Oxford QuARC Electronics Testing

Simon Jolly

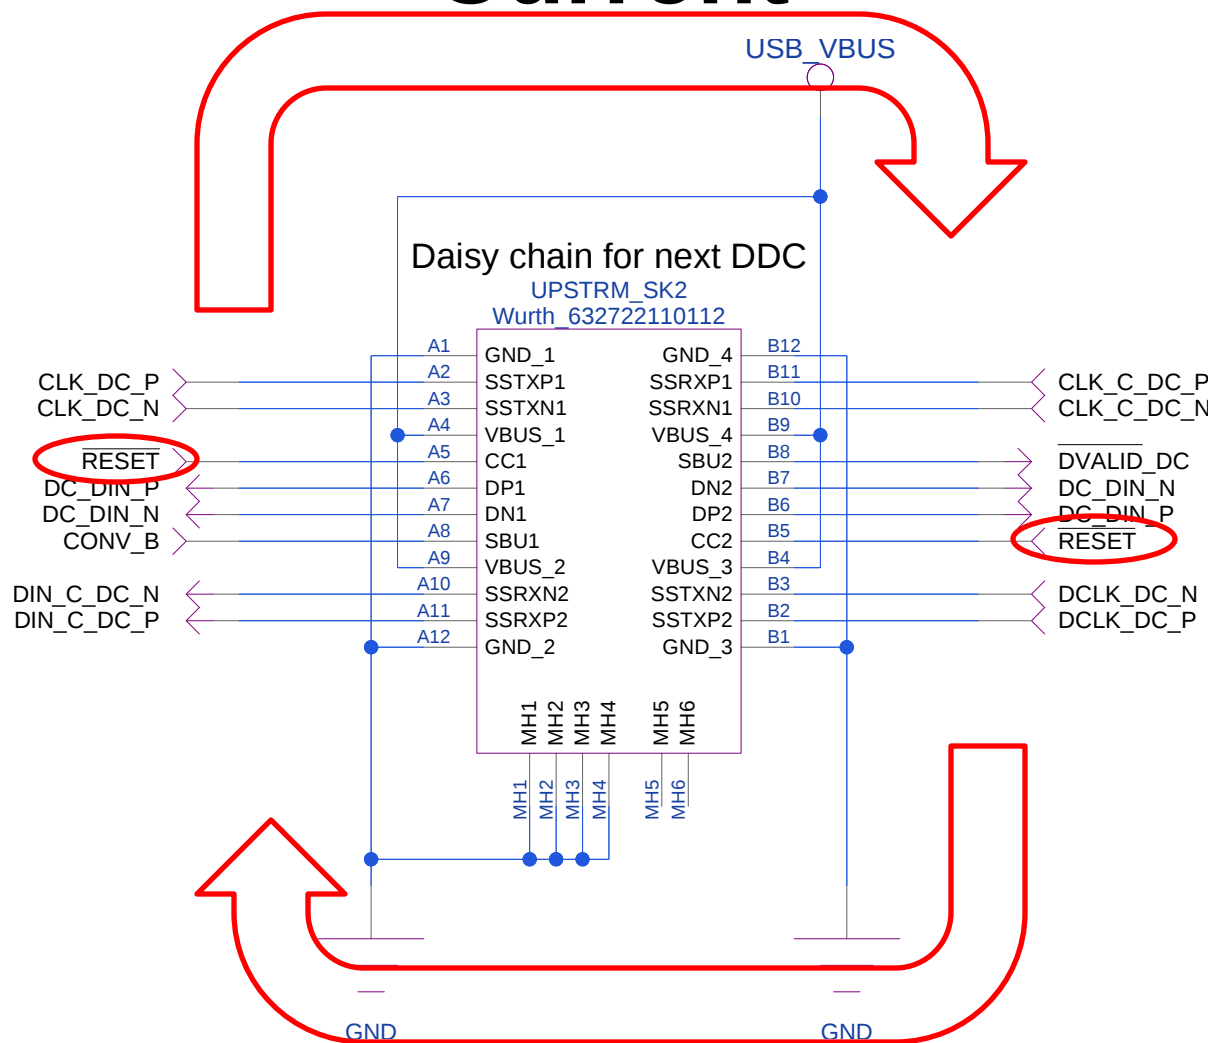
- “Upstream” USB-C socket on DDC board needs rotating 180 degrees: currently all USB-C board-to-board interconnects need 180 degree twist.
- RESET passthrough on DDC does not come from Schmitt trigger: should be RESET_B.
- We cannot fit photodiodes: DDC board is missing pin inserts.
- Not clear whether USB-C cable/connector shielding is correctly grounded.
- Some signals look messy (but everything still works...).

Current

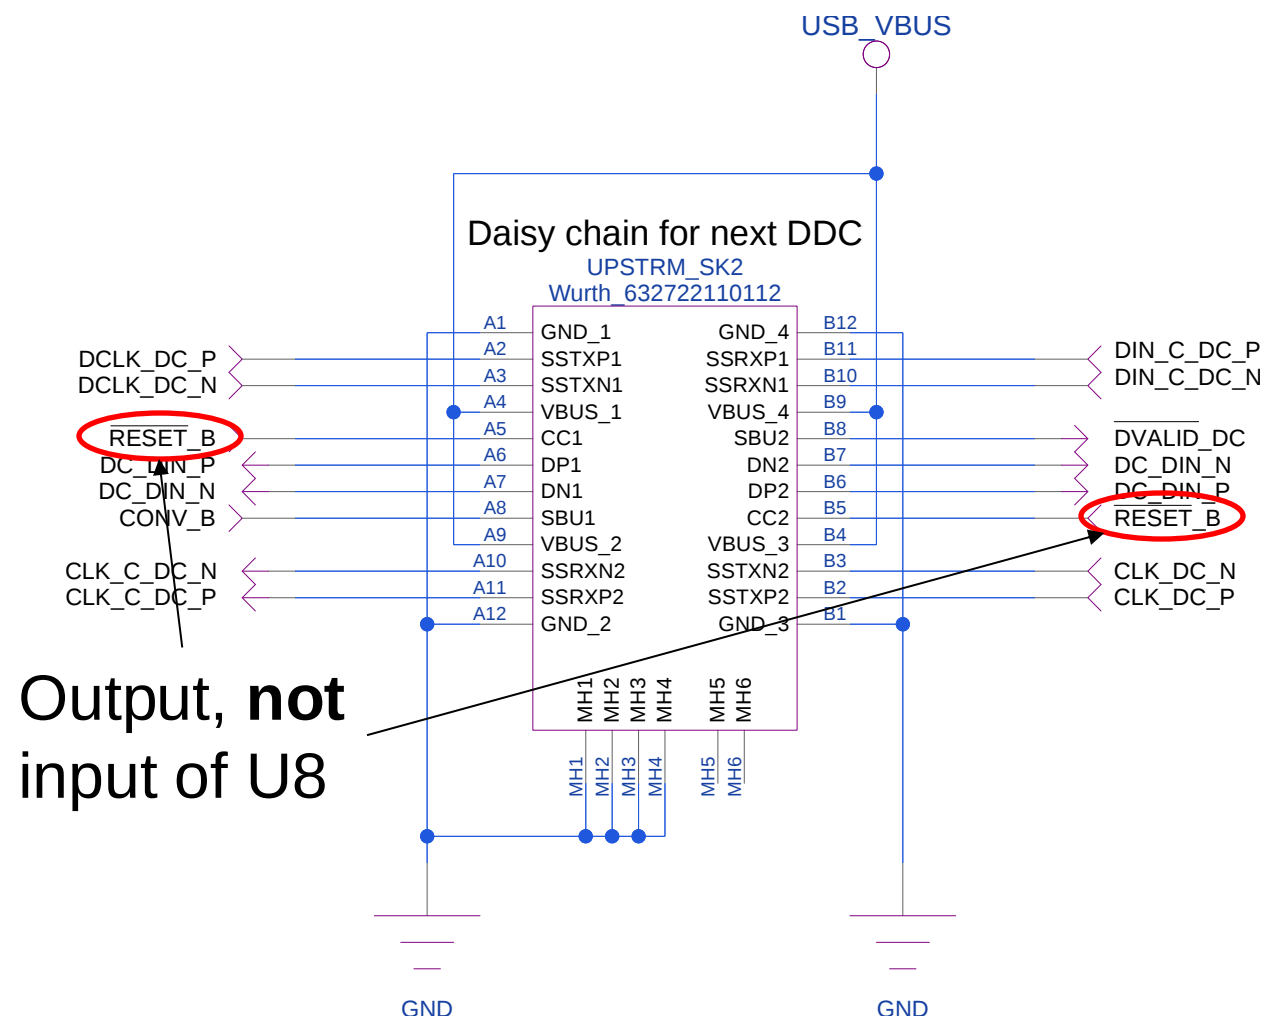
- DDC boards need pin receptacles soldered to board to take photodiode legs:
 - Need to plug and remove.
 - Adds small amount of elasticity.
- Mill-Max:
 - 0566-1-15-15-21-27-10-0
 - 2 per diode.
 - 64 per board.
- Available from Mouser, Digikey, Farnell.
- Can they be retrofitted to existing boards?

RESET Signal Ringing

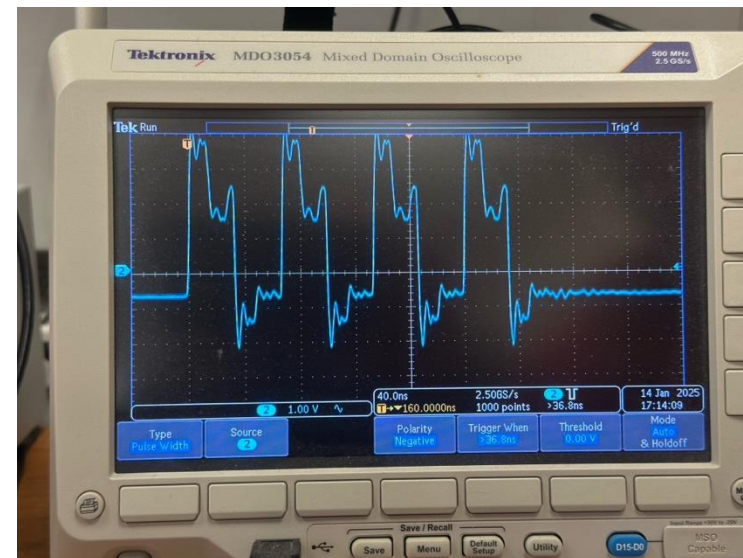
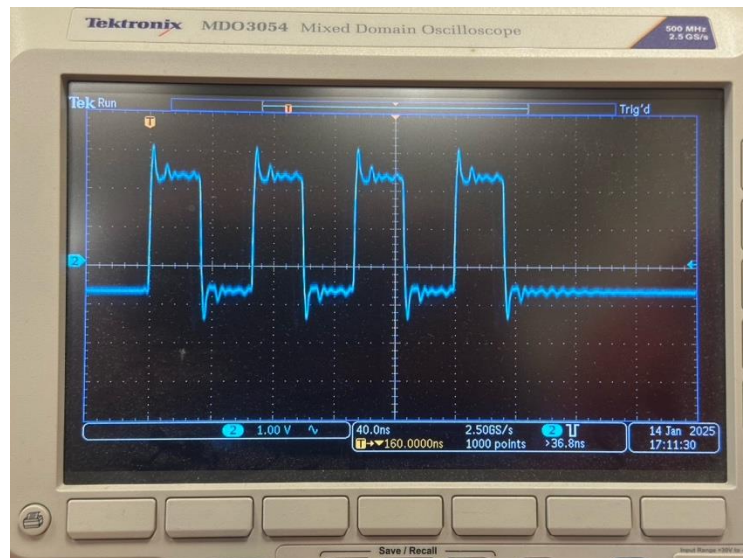
- Some of the digital pulses on the board look... “interesting” ...
- Lots of ringing on rising and falling edges.
- Single-ended RESET pulses become more distorted: perhaps due to non-buffering from Schmitt trigger?
- Do USB-C signals need terminating on DDC board? Shouldn't LVDS buffers etc. be enough?
- May also be due to poor/incorrect termination on scope probe: ringing **not** seen with differential probe.
- DAQ still seems to function perfectly despite this...

DDC Rev.E USB-C U/S (Updated)

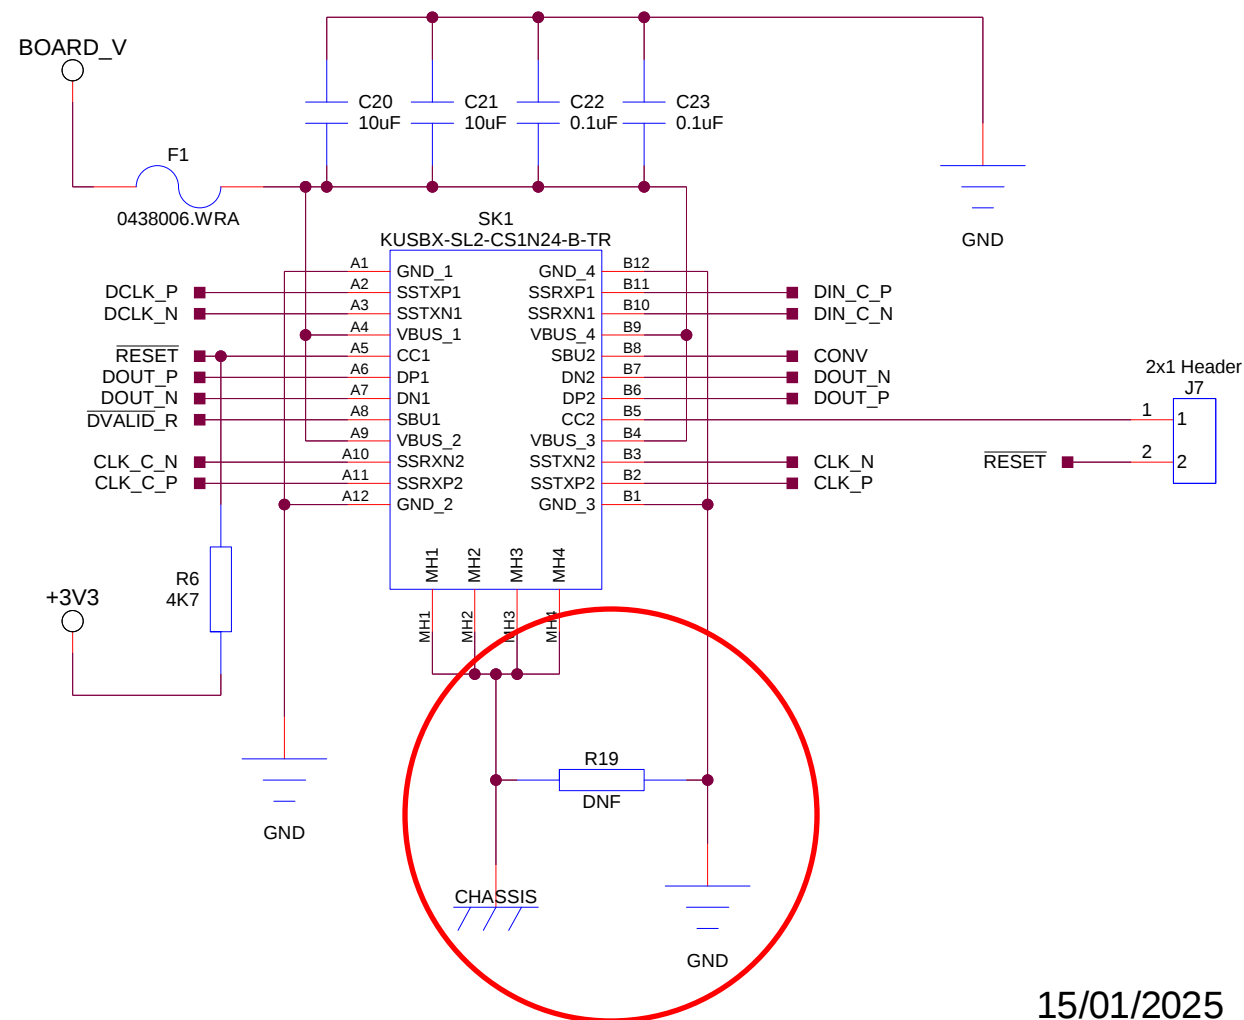
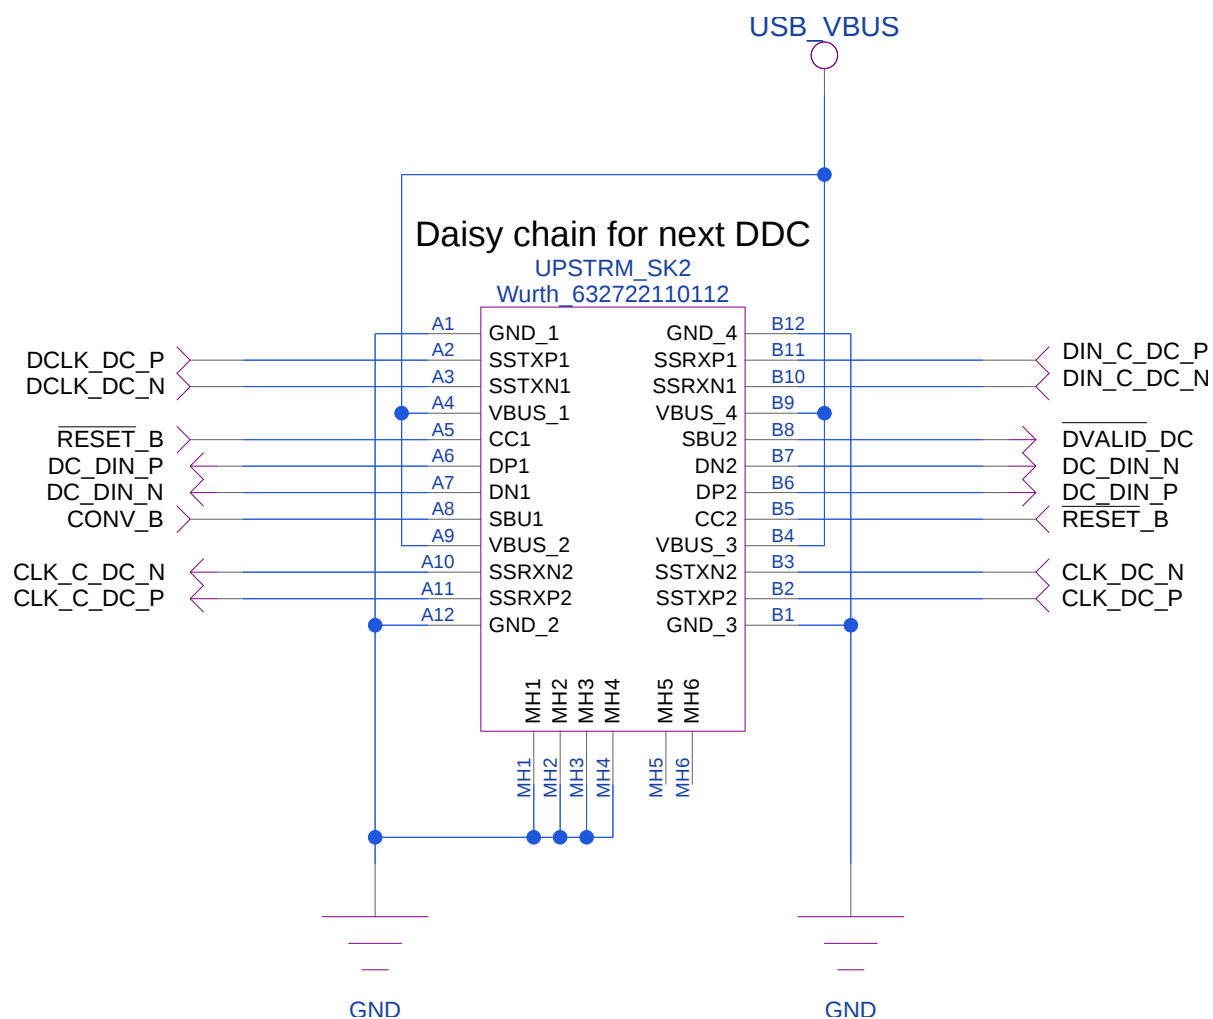
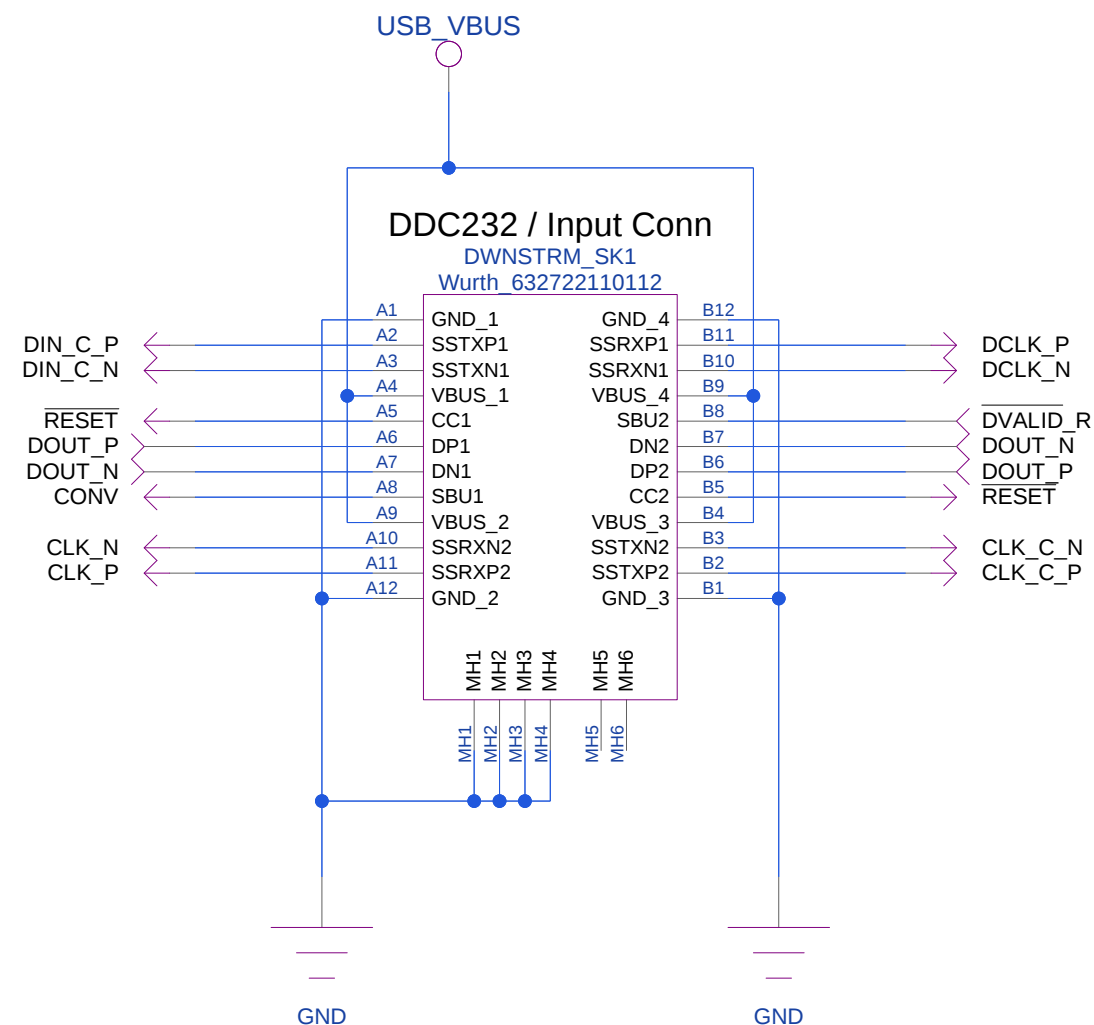
- I'm not sure this is an issue, but worth clarifying.
- Where, if at all, is the USB-C shield supposed to be connected to ground?
 - Currently connected on both sockets of DDC board but left open on ZMOD v.2 (R19, DNF).
 - Not connected **anywhere** on Cosylab design: reason for noise...?
- USB-C specs say:
 - 11. The receptacle shell **shall** be connected to the PCB ground plane.
 - 12. All VBUS pins **shall** be connected together in the USB Type-C plug.
 - 13. All Ground return pins **shall** be connected together in the USB Type-C plug.
- So this implies that shield should be connected to ground at every socket.
- Where is “chassis” on ZMOD?
- Modify ZMOD with 0R at R19...?
- <https://www.usb.org/document-library/usb-type-c-cable-and-connector-specification-release-24>

- Design is sound for both ZMOD and DDC boards.
- **NO** changes needed for ZMOD to work:
 - Just check USB-C ground-shield connection. Fit R19?
- DDC board design works but small mods needed:
 - **Add pin receptacles** to take photodiodes.
 - **Rotate** upstream USB-C socket (wiring) by 180 degrees so match downstream orientation.
 - Pass Schmitt triggered **RESET_B** to upstream socket, not RESET.
- Cause of ringing/distortion of square pulses? Is this an issue?
DDC boards seem to work...
